PARTS BULLETIN

No. 3-22

Subject: New Pro-D Fertiliser Boot V2 Kit

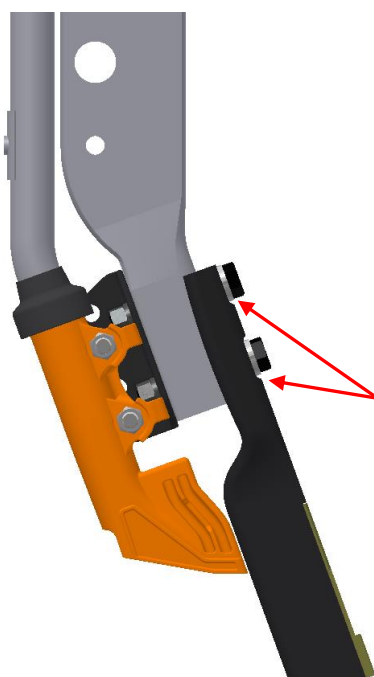
Ausplow has introduced a NEW Pro-D Fertiliser Boot V2 incorporating a wear shield that will replace the current Pro-D fertiliser boot, shield and strap.

The NEW single piece shielded boot, like the current boot, will also allow depth adjustment from 3" or 4". There is now provision to simultaneously fit two 6mm OD liquid friction flow tubes.

The Fertiliser Boot V2 Adaptor is bolted to the back of the shank using the blade bolts and the fertiliser boot is bolted to the adaptor using two of the 4 holes in the adaptor depending on the 3" or 4" depth setting required.

Fitting the fertiliser boot to the tine assemblies will require the 32mm stainless steel fertiliser tubes. The lower fertiliser tube clamp is now removed. The rubber Fertiliser Boot Protection Cap is fitted first to the fertiliser tube prior to attaching the boot.

Pro-D Fertiliser Boot V2 Kit

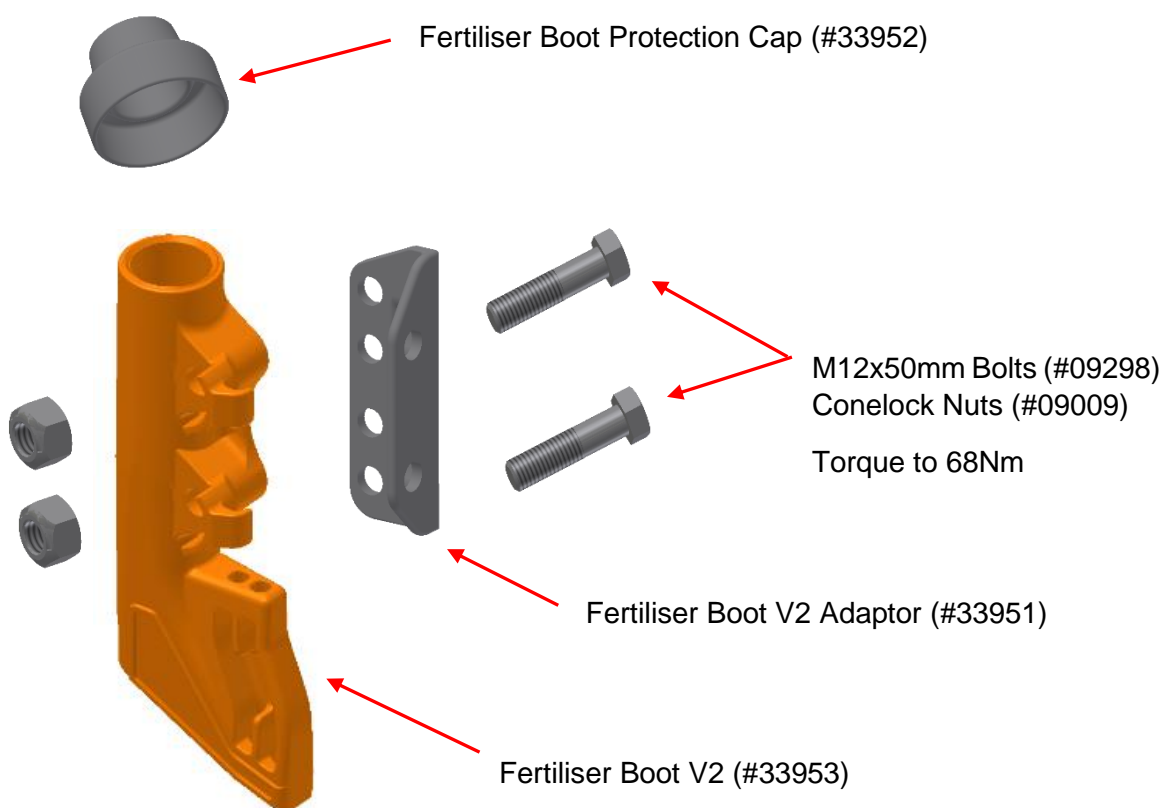
When fitting the adaptor, two #09031 M12 Flat Washers will be required and placed under each blade bolt head to ensure the DBA blade bolts do not interfere with the boot fitting on the adaptor.

The new V2 Fertiliser Boot and its adaptor are not interchangeable with the existing shield, boot, and adaptor.
